MEMO

Date: February 26, 2016

Subject: Caloosahatchee River Basin Watershed Model Review and Calibration Refinement –
Draft Task 1 Findings and Recommendations

Figure 2: HSPF model subbasin delineation and reaches

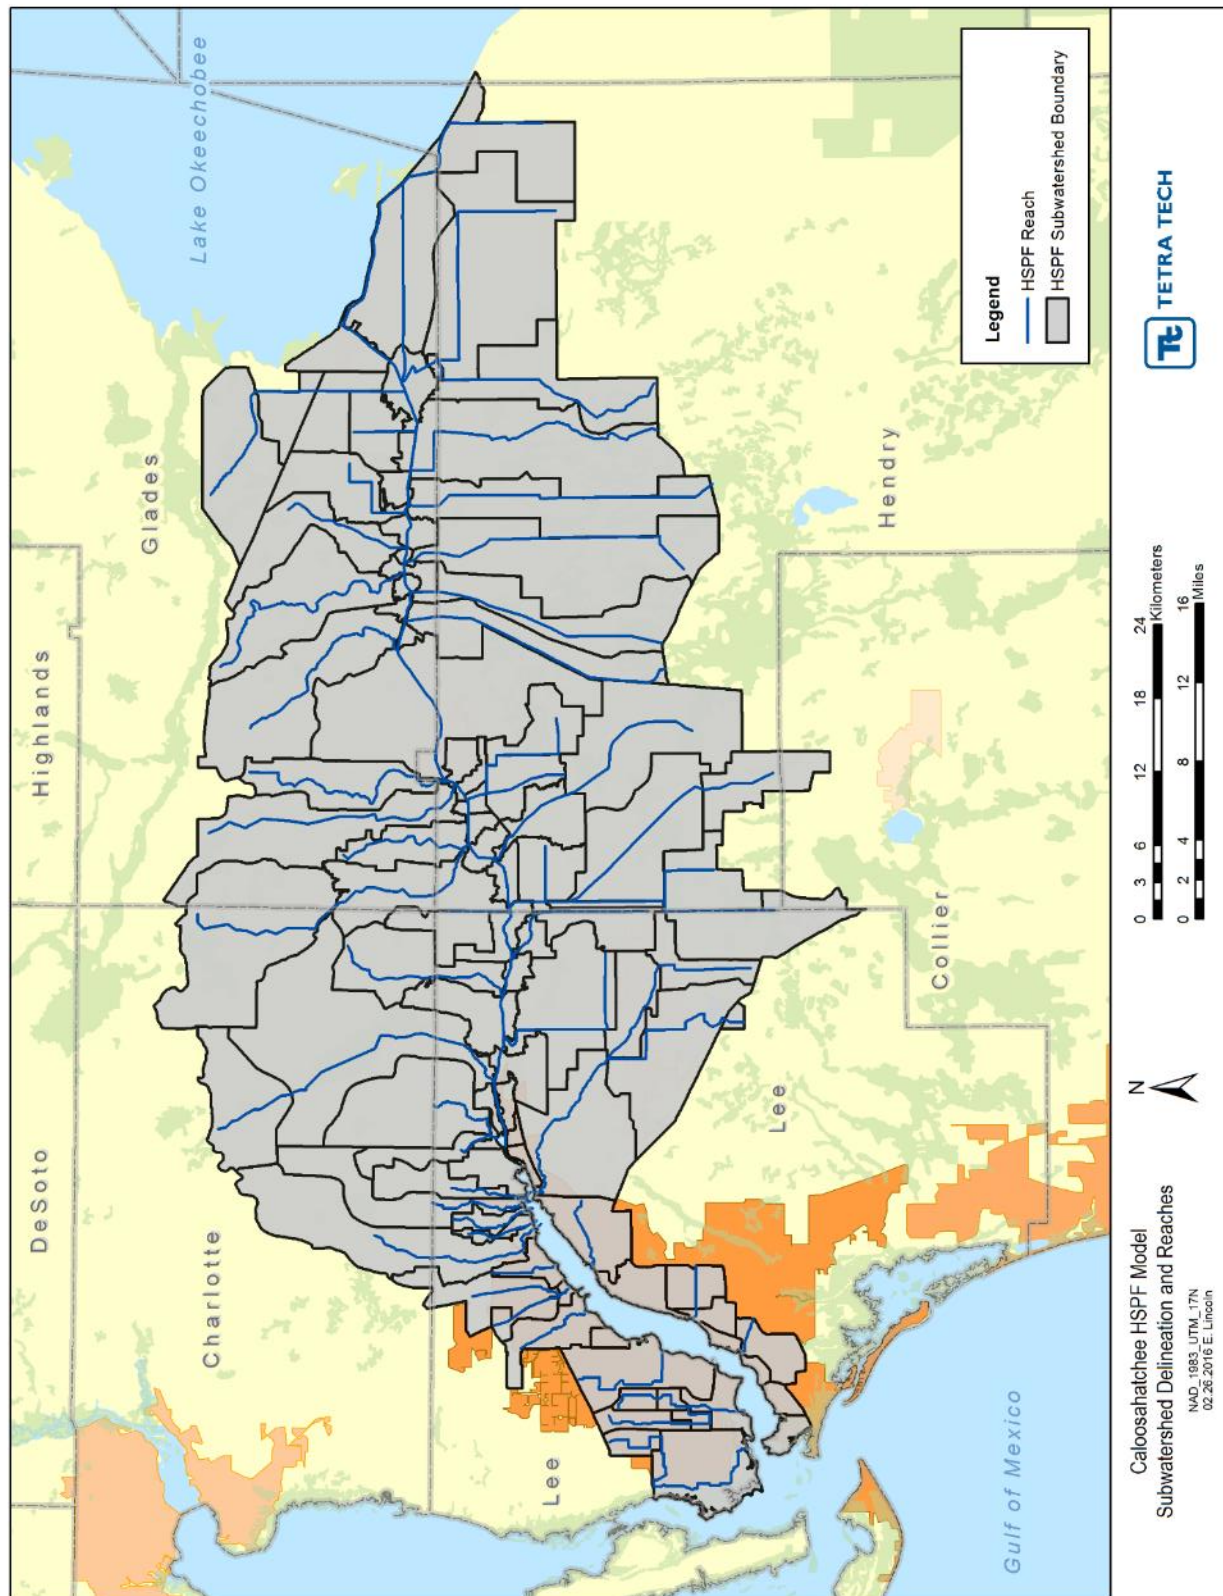
The setup of the model segmentation and hydraulics seems reasonable in terms of the F-Table representation of reaches and lakes where simulated outflows, as reported by Dynamic Solutions (2009), are generally representative of observed conditions. In addition, reaches 46 and 18 are associated with river locks S-78 and S-79, respectively, and have F-Tables that generally capture the impoundment effects of these structures. Select areas in the watershed have been identified by the department as having complex hydraulics that are not fully represented by the current reach and F-Table setup. These locations include the City of Cape Coral canal networks and Deep Lagoon Canal, and representation may require additional delineation of the existing HSPF subbasins to properly capture hydrologic conditions. Additional delineation may also be necessary to generate model output at the locations of select water quality monitoring locations.

Figure 6: Unit area flows by land use

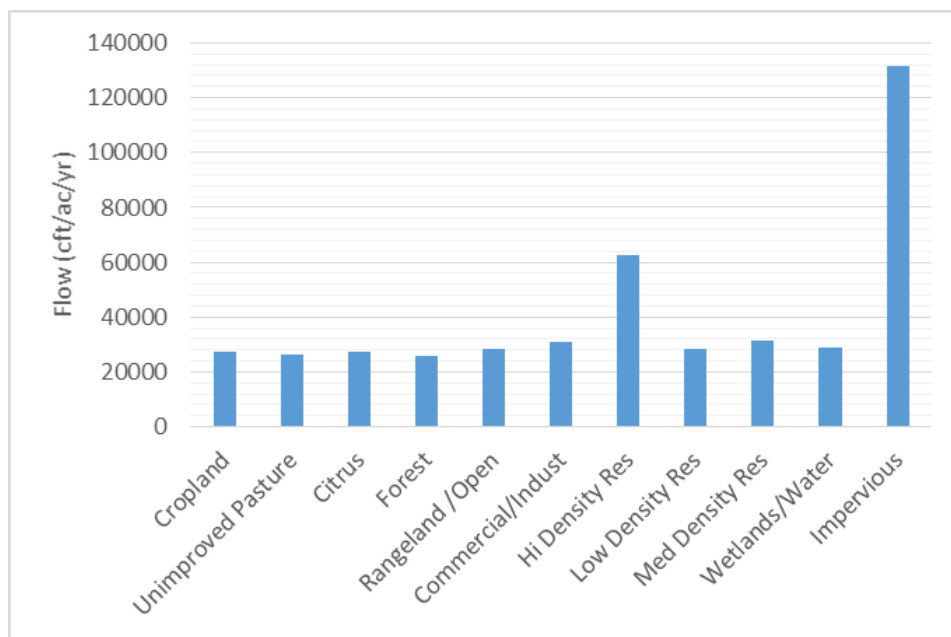
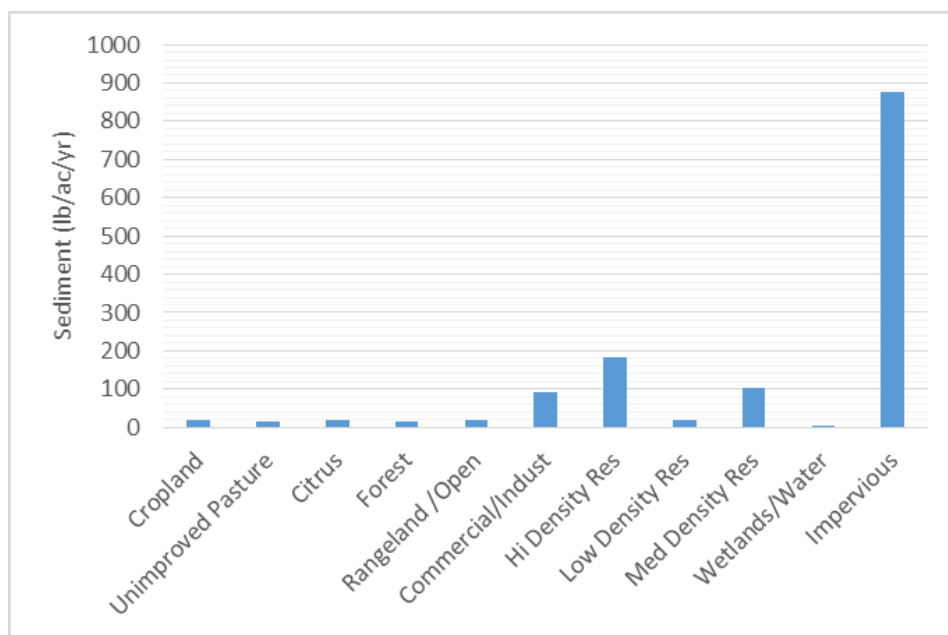
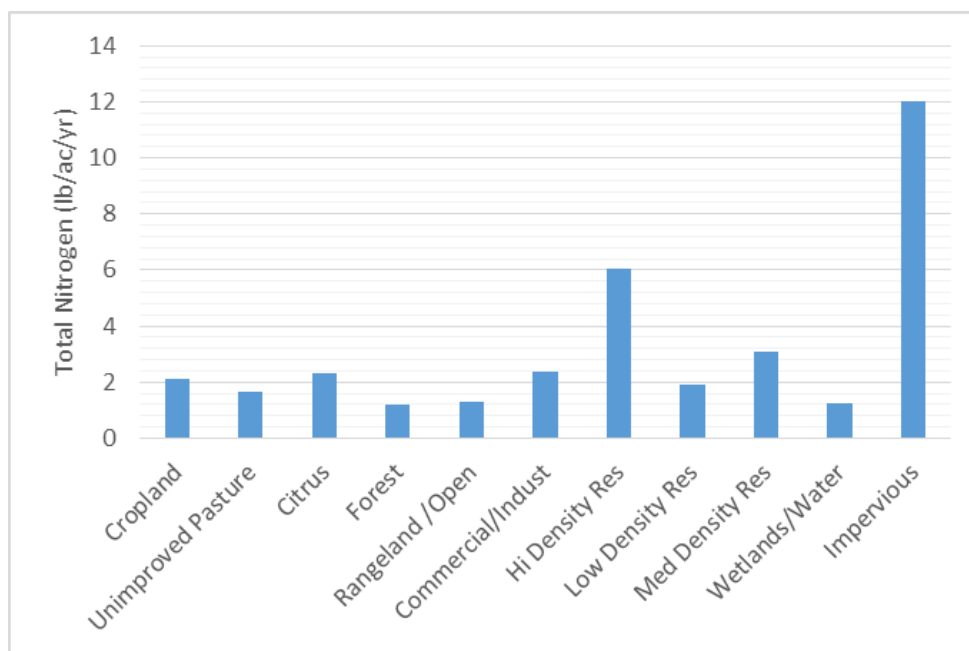
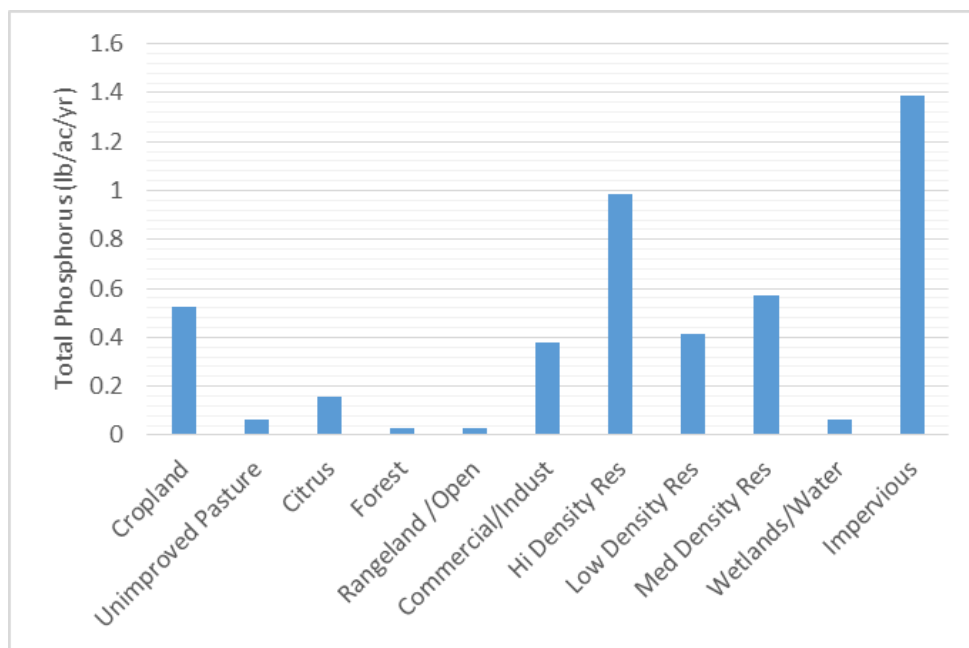
When loads are transferred from the upland simulation to the reach simulation, assumptions are made for disaggregating upland parameters to instream constituents as shown in **Table 1**. The only disaggregation that is referenced, however, is the relation of ORP to ORN, which is described as being “based on [station] CES01 data” in the model UCI file notes. For the remainder of the modeled pollutants (sediment, organic

carbon, and NO_x species) there is no documentation on how the splits were determined. Additional effort may be required to better characterize the disaggregation. It should be noted that BOD entering reaches also implicitly contains labile forms of OrgN, OrgP, and organic carbon determined by ratios set within the RQUAL module. These labile forms are converted to inorganic nitrogen, phosphorus, and carbon when BOD decays. A summary of the unit area pollutant loads from the 2014 Model by model land use are provided in **Figure 6** through **Figure 9**.

Figure 10: HSPF flow calibration stations

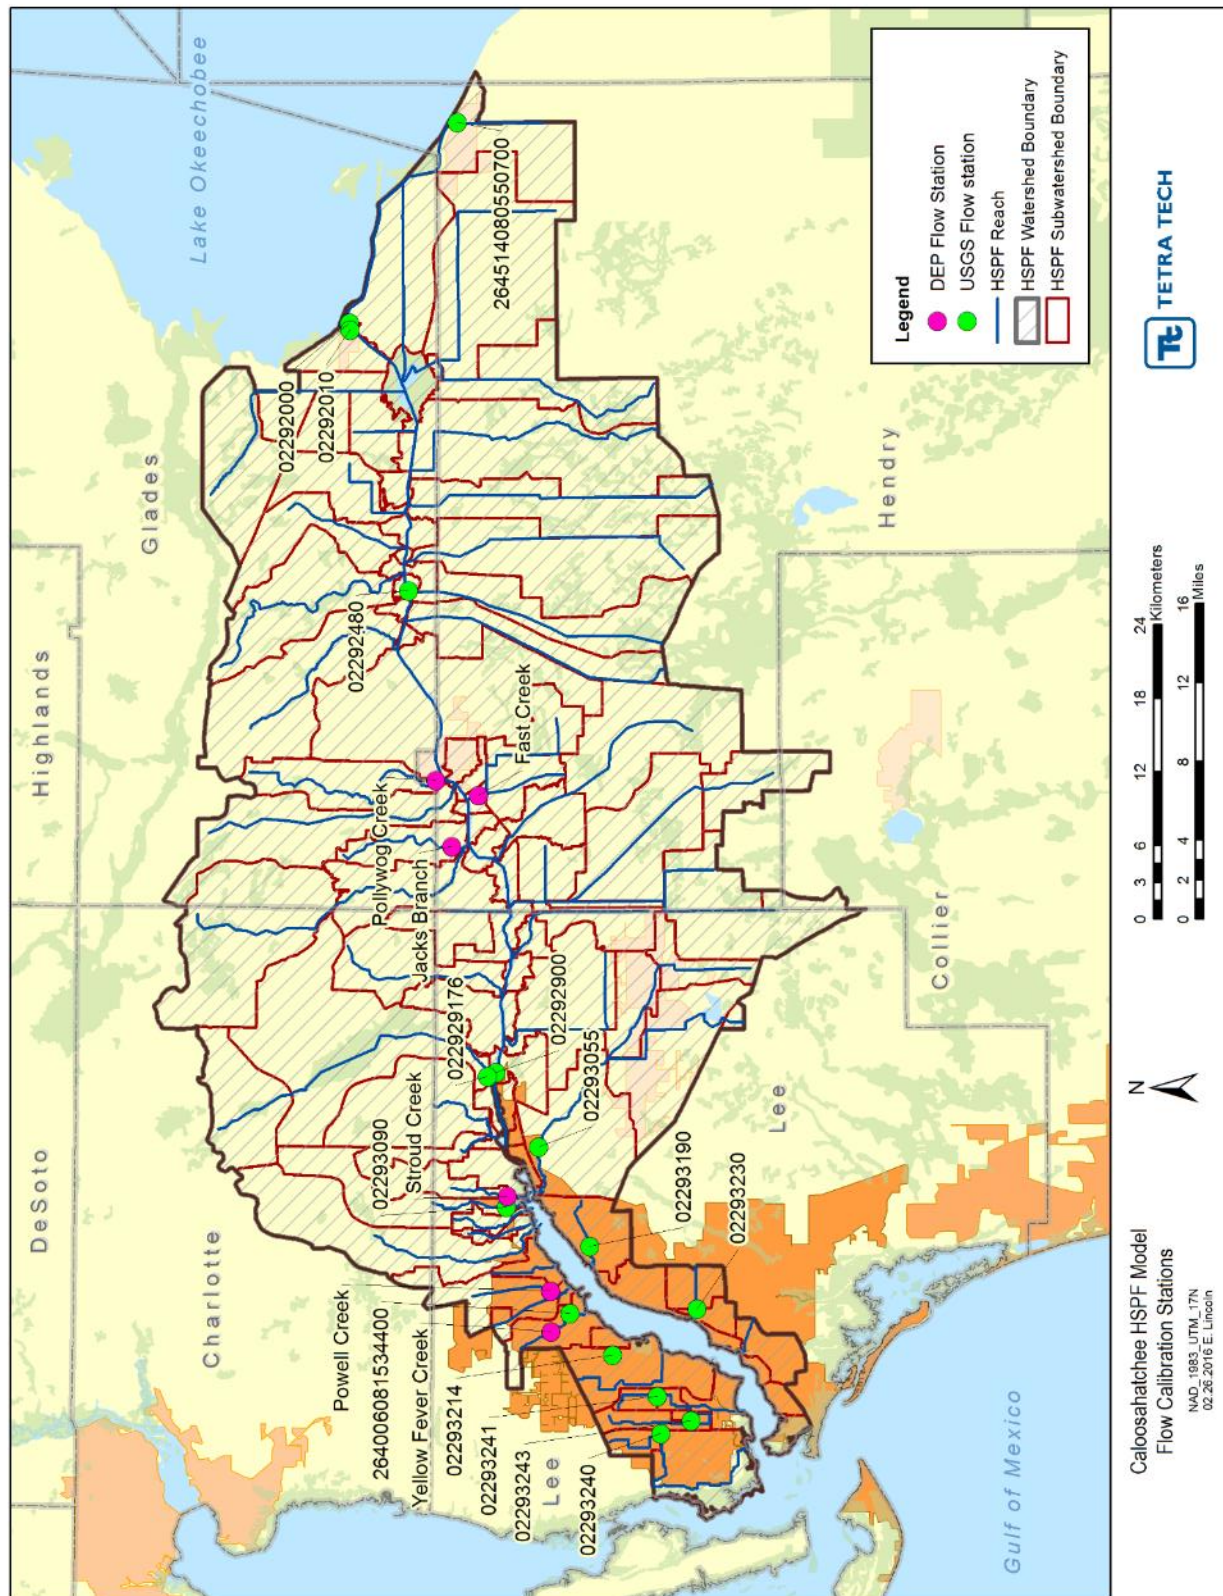
Issue #2: (*Stakeholder comment*) Model watershed delineations and reach segmentation may not correctly represent some watersheds, and are not delineated to some flow stations that will be used in the 2017 Model.

Six of the 21 flow stations in the Caloosahatchee watershed were identified that are not located in close proximity to a subbasin outlet (**Table 5** and **Figure 10**). Two of the stations, 02292000 and 02292010, are located at the upstream boundary condition of the HSPF model at the beginning of the C-43. These stations will be used to verify the S-77 Lake Okeechobee boundary condition, but will not be used for HSPF model calibration. Station 02293214 is located on a small canal in Cape Coral, and redelineation is not recommended for this location. Tetra Tech recommends updating the HSPF model delineation so stations 264514080550700, 02293055, and Yellow Fever Creek are located at subbasin outlets to allow for model calibration or validation at these stations.

Recommendation: Overall, the current model watershed delineations and reach segmentation were determined to be appropriate. Lee County provided the department with information on minor modifications to the southern boundary of the Deep Lagoon Canal watershed, and these changes will be incorporated in the model.

Figure 12: Dominant agricultural irrigation water withdrawal source

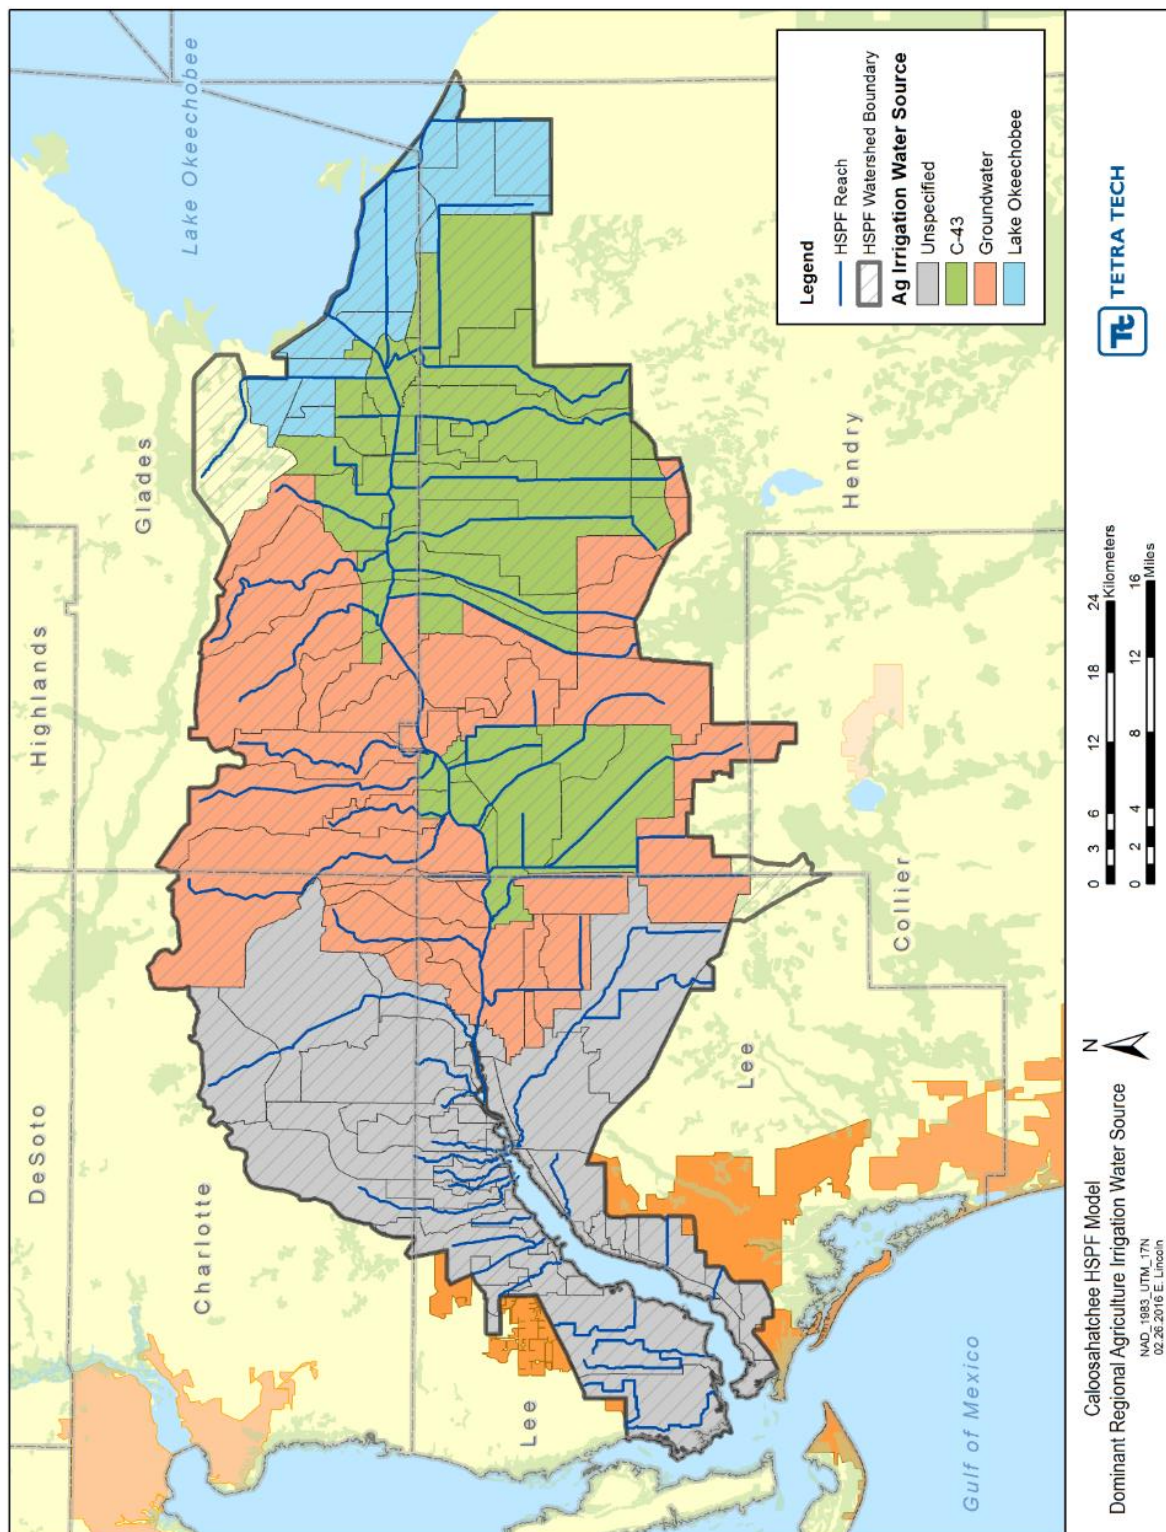
Issue #7: Representation of agricultural irrigation volumes and withdrawals may not properly represent withdrawal and demand.

Recommendation: The model currently represents agricultural irrigation as a point source that discharges directly to the HSPF model reaches, but the source of the water is not specified. Tetra Tech recommends that irrigation continue to be represented, but as a point source applied to the land. Information from the department on the source of the water (C-43, Lake Okeechobee, or ground water) will be used in the model (**Figure 12**). The irrigation will be represented in the model as a demand.

Figure 15: Caloosahatchee EFDC bottom elevations

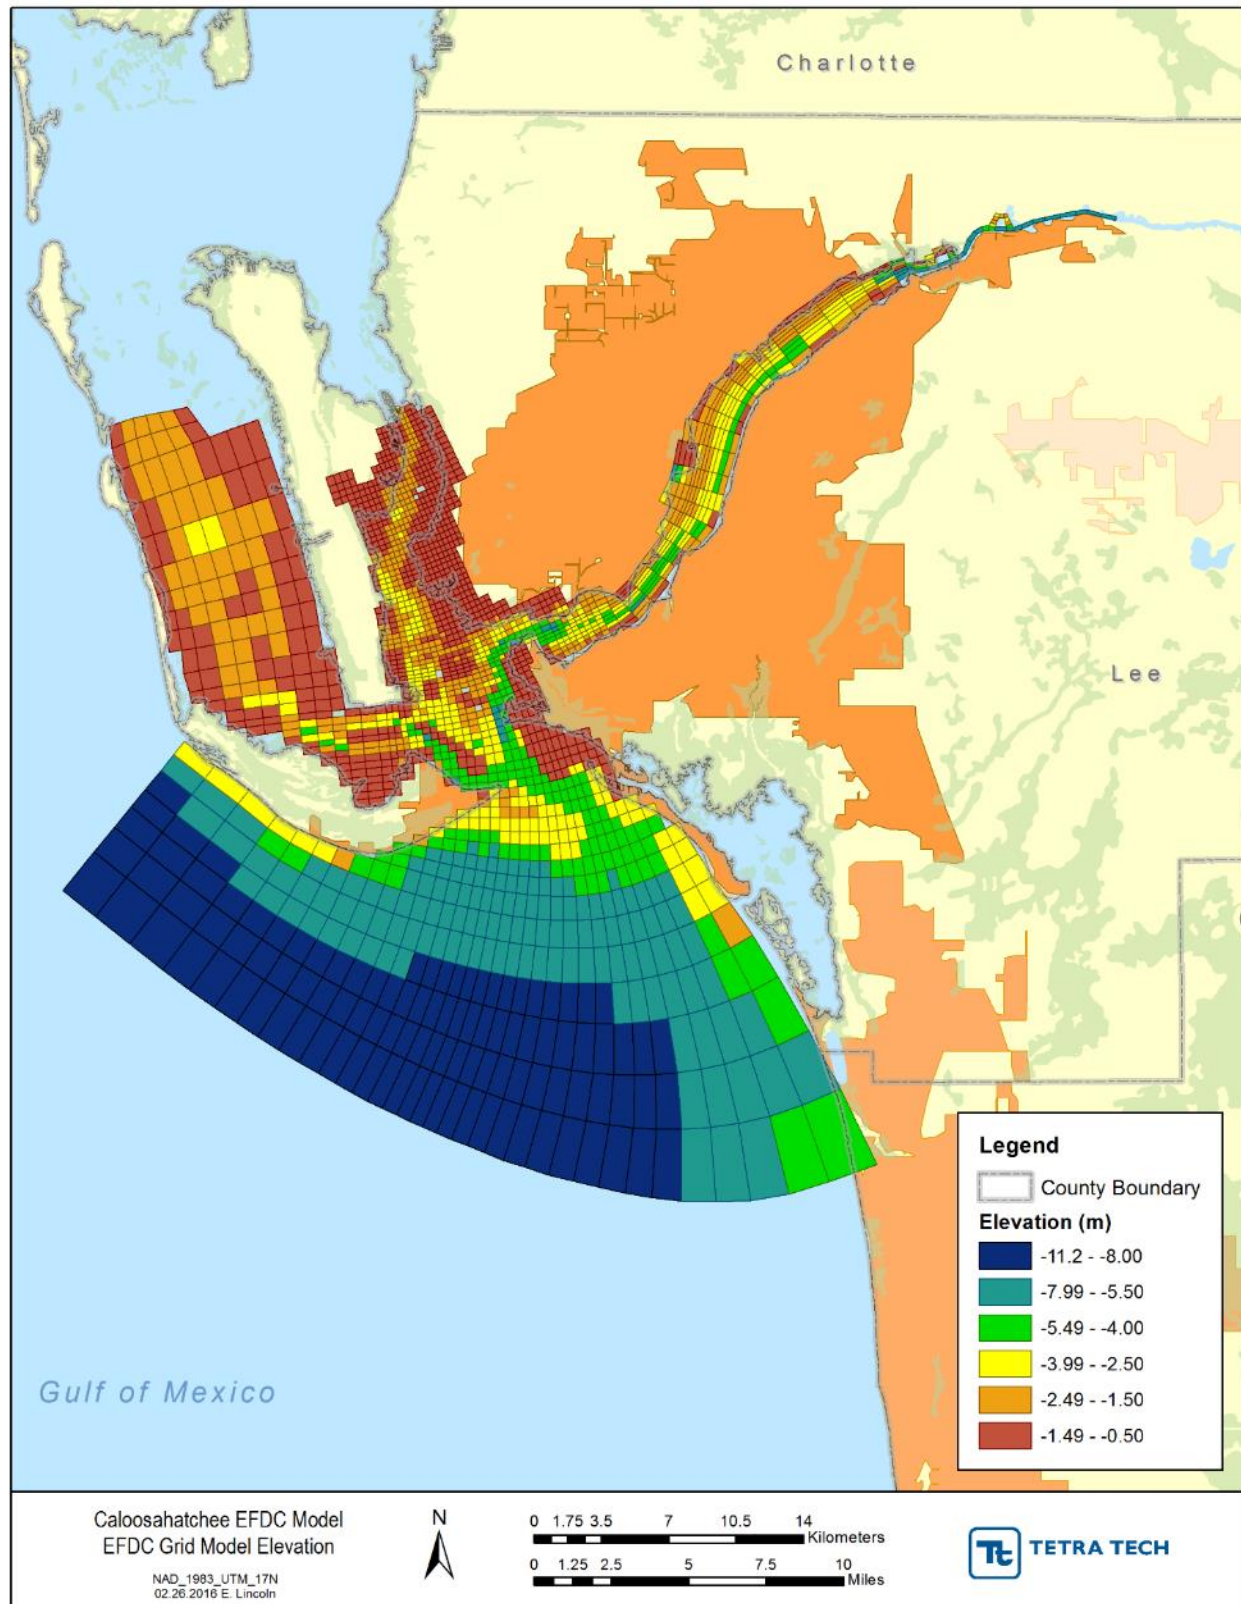
The original bathymetry appears to be from online NOAA depth data and should be adequate for this project. However, these data need to be checked against NOAA nautical charts to ensure the data are translated to the model grid correctly (**Figure 15**).

Recommendation: The initial depths should be revised to follow the bottom elevation.
